ADDENDUM #1

TO CONTRACT DOCUMENTS FOR: Project #CP262051 – Memorial Stadium Sideline Power Installation

PREPARED FOR: The Curators of the University of Missouri

2 E1.1 WEST CONDUIT ROUTING ELEVATION
SCALE: 3/16" = 1'-0"

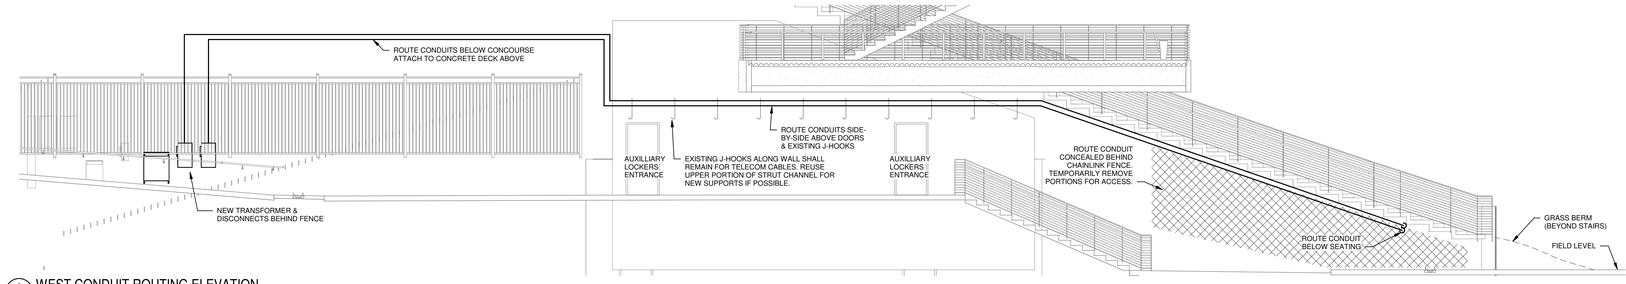
DRAWINGS:
Revise the following Drawing Sheets as follows:
1) Drawing sheet E1.1: **REPLACE** sheet E1.1 dated 9/10/2025 in its entirety with revised sheet E1.1 dated 10/23/2025 attached. Added key notes #7 and #8, pictures and additional details regarding conduit routing along the west sideline.

7. THE EXISTING CONCRETE STRUCTURAL WALL BELOW THE SEATING MAY NOT ALLOW ACCESS TO INSTALL THE CONDUITS NORTH OF THE STAIRS. THE CONTRACTOR SHALL CORE DRILL AN EXPLORATORY HOLE THROUGH THE WALL TO DETERMINE THE FEASIBILITY OF ROUTING CONDUIT NORTH OF THE STAIRS AS INDICATED. THE HOLE SHALL BE THE APPROPRIATE SIZE FOR USE WITH THE NEW CONDUIT. VERTICAL SUPPORT COLUMNS SHALL NOT BE PENETRATED. USE RADAR SCANNER TO DETERMINE AN APPROPRIATE LOCATION PRIOR TO DRILLING. REPORT FINDINGS TO ENGINEER AND OWNER PRIOR TO CONTINUATION.

8. IF IT IS DETERMINED THAT CONDUITS ARE UNABLE TO BE ROUTED BELOW SEATING NORTH OF THE STAIRS AS SHOWN, THE CONTRACTOR SHALL ROUTE CONDUITS OUT OF THE BRICK WALL BELOW THE SEATING AND SURFACE MOUNT TO THE BRICK WALL AS REQUIRED. ROUTE CONDUITS THROUGH THE ADJACENT BRICK WALL AND BELOW THE CONCRETE STAIRS INTO THE GRASS BERM AS REQUIRED. SEE PICTURES OF ORIGINAL CONSTRUCTION AND PROPOSED ROUTING OF SURFACE MOUNT CONDUIT. PROVIDE PULL BOXES AS REQUIRED.

2 / E1.2 EAST CONDUIT ROUTING ELEVATION
SCALE: 3/16" = 1'-0"

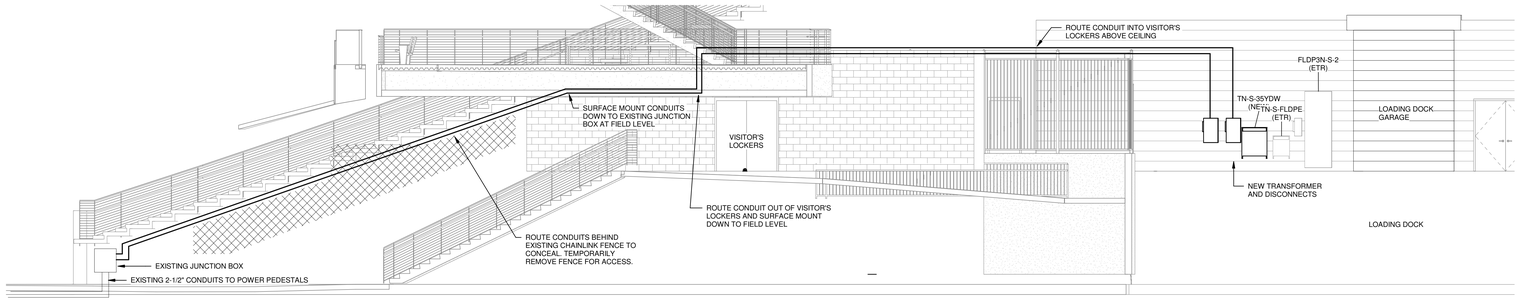
2) Drawing sheet E1.2: **REPLACE** sheet E1.2 dated 9/10/2025 in its entirety with revised sheet E1.2 dated 10/23/2025 attached. Added key note #7 and an alternate path with image for east conduit routing.

3 ALTERNATE EAST CONDUIT ROUTING
NTS

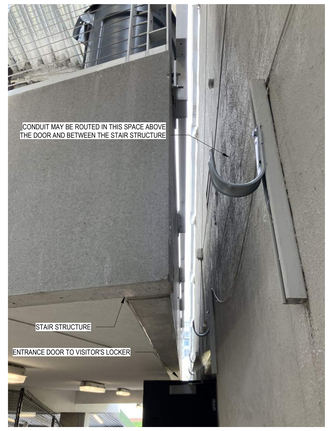
7. AT CONTRACTORS PREFERENCE, CONDUITS MAY BE SURFACE MOUNTED IN THE LIMITED SPACE BETWEEN THE VISITOR'S LOCKER AND THE ADJACENT STAIR STRUCTURE. INSTALL CONDUITS HIGH UP ABOVE THE DOORS WHERE EXISTING J-HOOKS HOLD TEMPORARY CONDUCTORS FROM THE GENERATOR.
